# Metorex

March 5, 1999

This letter is in response to your letter of February 10, 1999 regarding the amendment request for the Metorex (formerly Outokumpu Electronics) registration certificate NR-701-D-101-B. The following are responses to your points:

## Description of Reference Source Holder for SSPS Probe

FIGURE 1 - LABORATORY SAMPLE PROBE FOR THE MODEL 840 AND THE MODEL 820

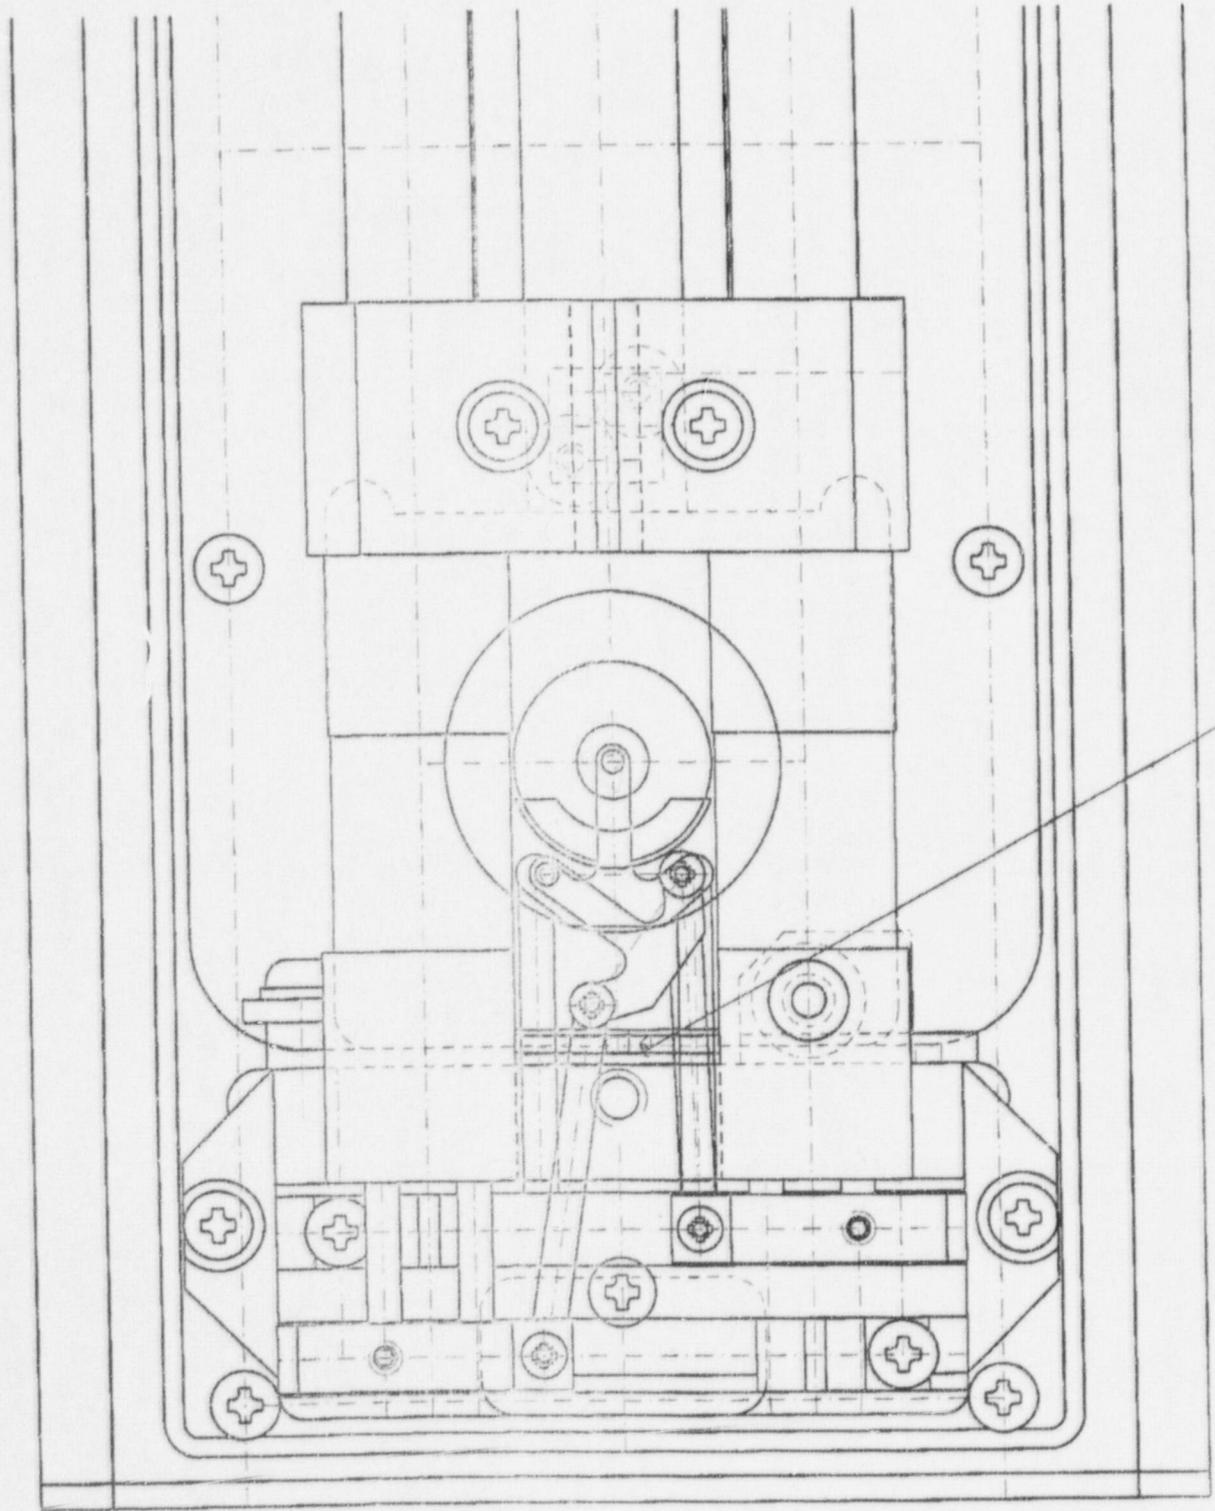
1. The description of the HEPS probe has been modified to give the source registration numbers instead of the manufacturers part number (see page 11).
2. The SSPS modifications are described on page 1. Several additional drawings have been added with information on the push rods and assembly.
3. The radiation measurements were labeled properly, if in a somewhat confusing manner. The measurements for the probe with shutter closed were made on the probe not mounted in the Cell Box. This is the radiation which might be experienced by a service engineer. The measurements made with the shutter opened were made with the probe inside the Cell Box. These measurements were made outside the Cell Box as this is the normal operating configuration.

The design of the SSPS probe has been modified to add a 50kBq Cd-109 source to the unit to provide a reference spectrum when the probe is inactive. Figure 1 on page 2 illustrates the operation of the mechanism. When both sources are off, the reference source is positioned over the detector. When either source is active, the reference source is placed off the detector axis. The general construction of the reference source holder is shown in Figure 2 on page 3. The reference source is placed in the holder and then covered with a silver cover followed by an aluminum cover. These covers are glued into the holes and then secured by deforming the edge of the hole by hitting it with a conical shaped tool at four points as indicated in the drawing. The individual components of the mechanism are shown in Figures 4-7.

PHOTO 3

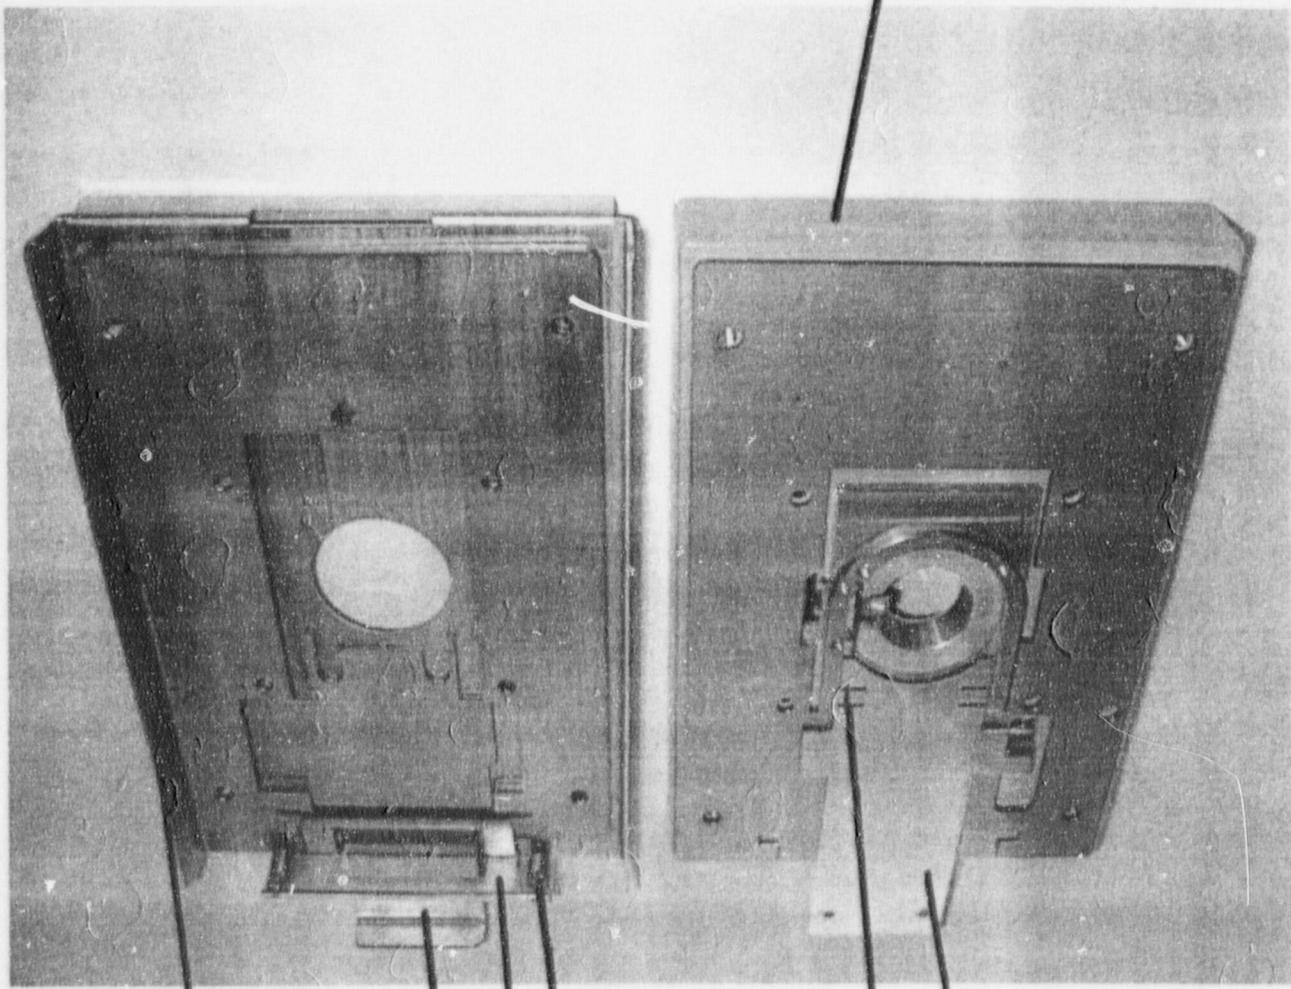
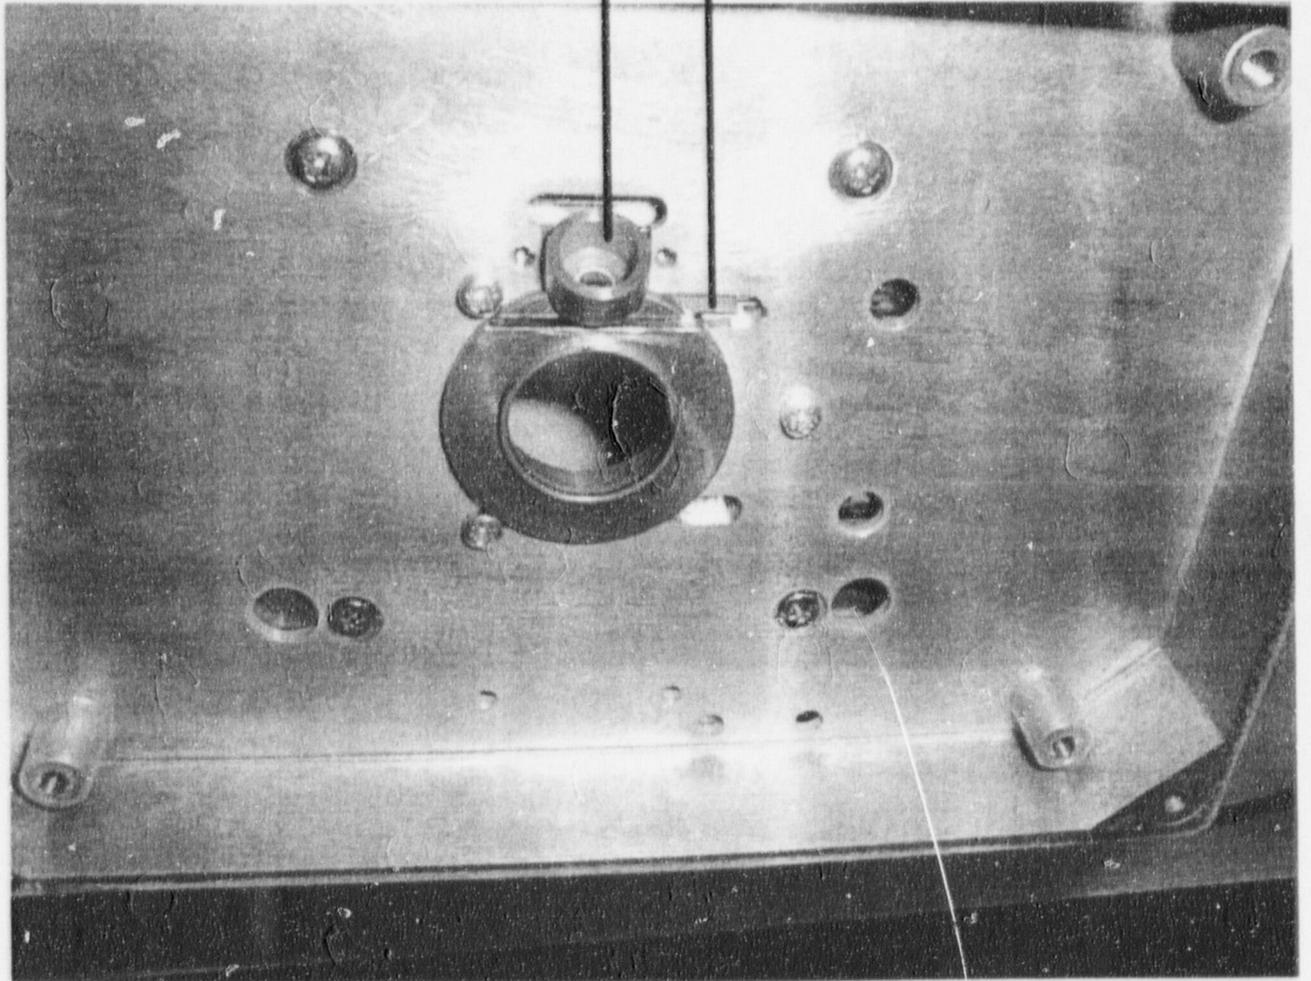
4. The description of the Courier 8 and the HEPS 2412 have been modified and several photographs have been added to better describe the shutter and interlocking mechanism of the probe.
5. Metorex intends to distribute both the modified SSPS and HEPS to persons generally licensed pursuant to 10 CFR 31.5 in accordance with the requirements of 10 CFR 32.51.

The radiation source (part 22 in fig 11.1) is located in the source holder (part 3 in fig 11.1 and photo 3 on page 16) so that the radiation is directed towards the sample. The shutter (part 13 in Item A on page 38 and in photo 3 on page 16) in the closed position is in a slot in the holder. Thus, the radiation is restricted to a very small space inside the source holder. A spring (part 14 in Item A) is used to insure that the shutter fits firmly in the slot.

The shutter is connected to the spring plate (part 9 in fig 11.1 and photo 2 on page 15) which is connected to the shutter conveyor (part 10 in fig 11.1 and photo 2) that moves along with the latch (part 11 in fig 11.1). When the probe is disconnected from the sample cell the spring loaded safety catch (part 12 in fig 11.1) prevents movement of the latch. When the probe is mounted onto the sample cell the lower part of the probe is pushed against the lower support (part 12 in figure 1 and photo 1) that lifts these fingers from the shoulder and releases the safety catch. This allows the shutter parts to be drawn down opening the
